10.0 Steam and Power Conversion System

The information in this section of the reference ABWR DCD, including all subsections, tables and figures, is incorporated by reference with the following departures and supplements.

Figure 10.1-1 Reference Steam and Power Conversion System

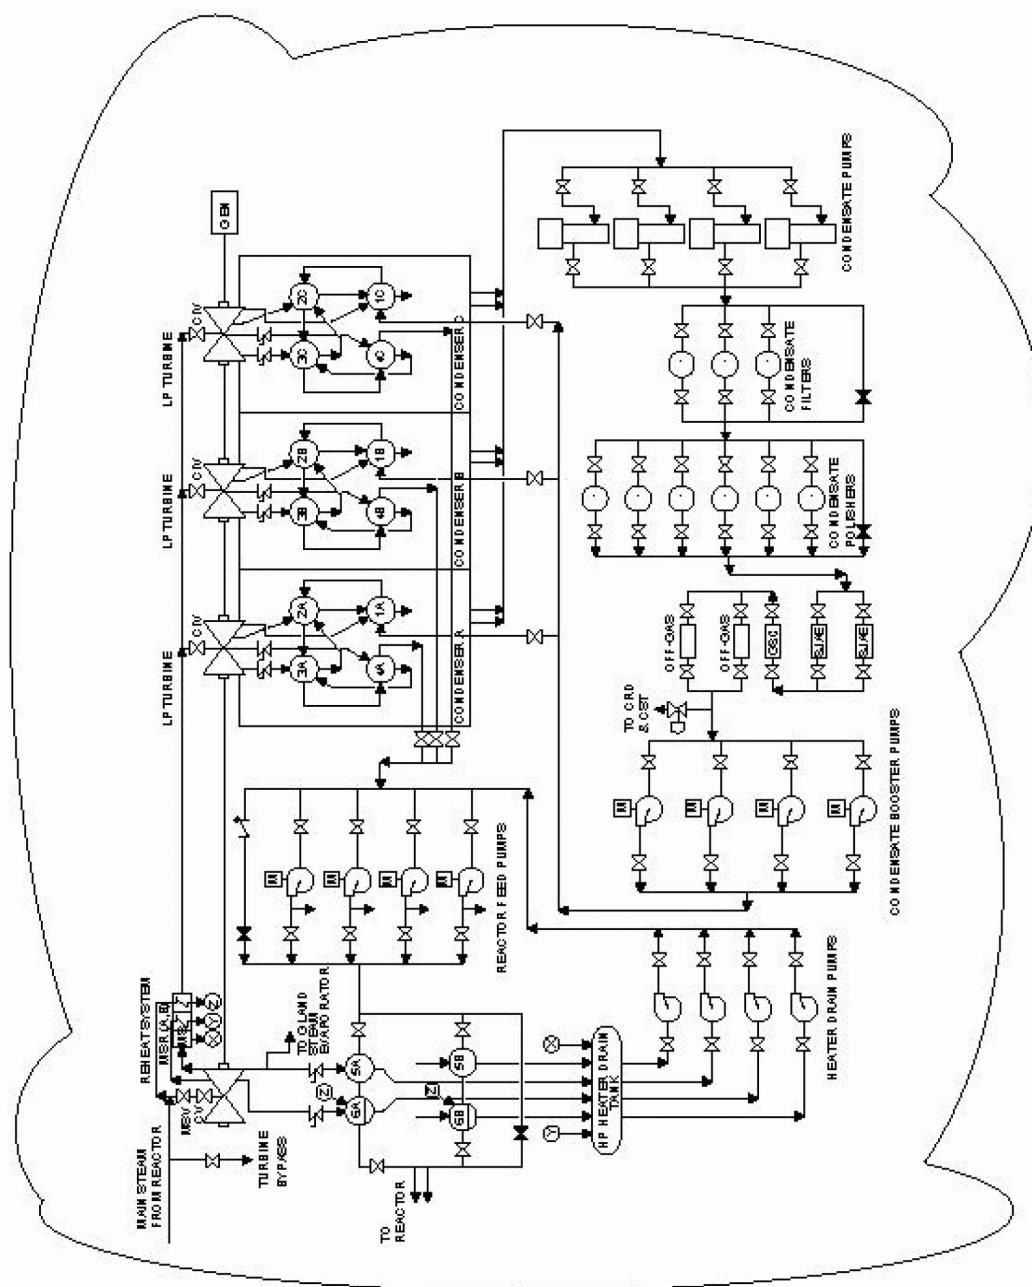
STP DEP 10.1-2 (Figure 10.1-1)

Major S&PC System design features are summarized in Table 10.1-1. The system main conceptual features are illustrated on Figure 10.1-1, assuming a triple pressure condenser. This type of condenser and other site dependent ABWR plant features and parameters are reported herein based on typical central U.S. site conditions. They are given here to more completely define the ABWR Turbine Island standard design and to be used as references in reviewing future ABWR plant specific licensing submittals, and confirming that such submittals are indeed consistent with the standard design. Nothing in the ABWR Standard Plant design is meant to preclude the use of a once through cooling system and a single pressure condenser nor will such changes affect the Nuclear Island.
